Public Comment No. 1064-NFPA 70-2024 [Global Input]

Public Comment No. 1643-NFPA 70-2024 [Global Input]

Figure 722.~~122 Limited-Energy and Communications~~ 122 Communications, Class 3, Class 2, and PLTC Cable Substitution Hierarchy.

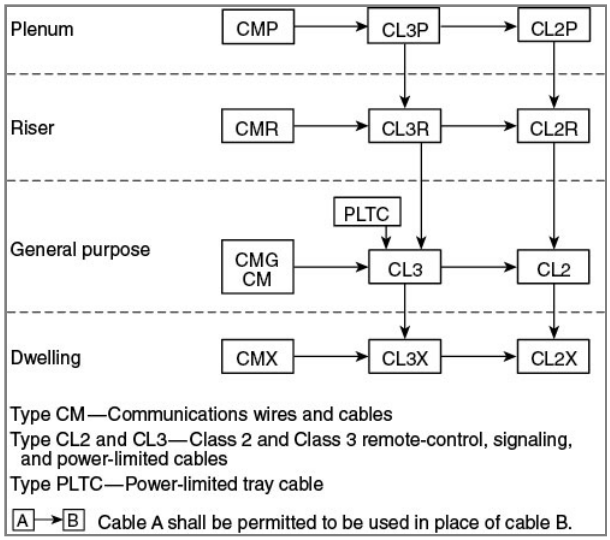
The title of Figure 722.122 should be revised to accurately describe what cables are in the figure. Not all limited-energy cables are in the figure, so using the term "limited-energy" in the title is too broad.
